INTERNATIONAL ELECTROTECHNICAL COMMISSION

IEC 60809
Edition 3.0 2014-12

**LAMPS FOR ROAD VEHICLES –
DIMENSIONAL, ELECTRICAL AND LUMINOUS REQUIREMENTS**

INTERPRETATION SHEET 1

Figure 1 – Category sheet for H19

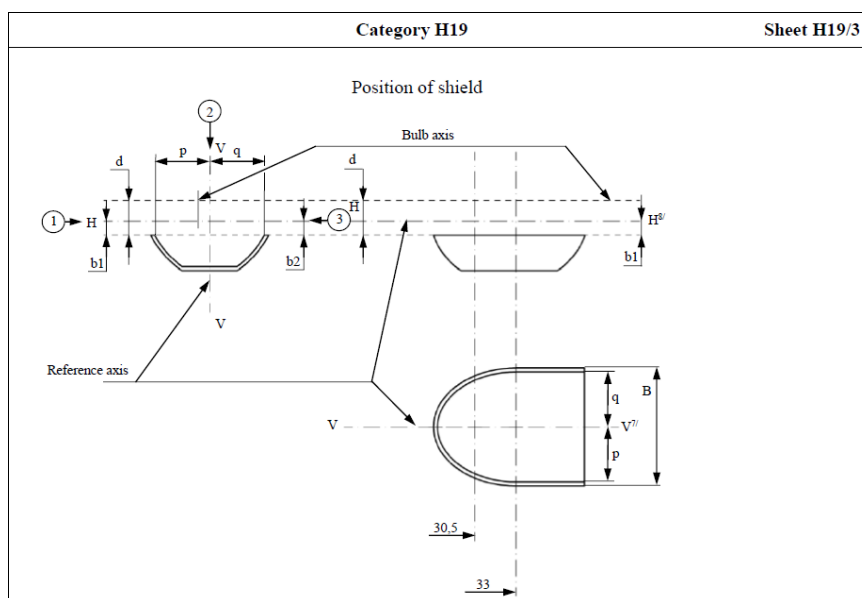
In the amendment of the current category sheet for H19 (Regulation No. 37), the distinct physical shield width B is introduced ($8,6 \pm 0,3$ mm) to ensure interchangeability of light sources as it relates to road safety (see WP.29/2016/111; to become Resolution [R.E.5] on the common specification of light source categories). In the category sheet for H19 reference is made to Annex E of IEC 60809:2014 for the method of measurement of the internal elements.

When using the above mentioned vision system, a measurement error is introduced due to refraction and blurring (by the glass envelope), additional to the measurement uncertainty.

The effect is mainly dependent on the shield width in relation to the glass envelope diameter.

For lamp designs with a relatively small glass envelope diameter (there is only an upper limit specified), the shield gets close to the glass envelope and the effect becomes significant.
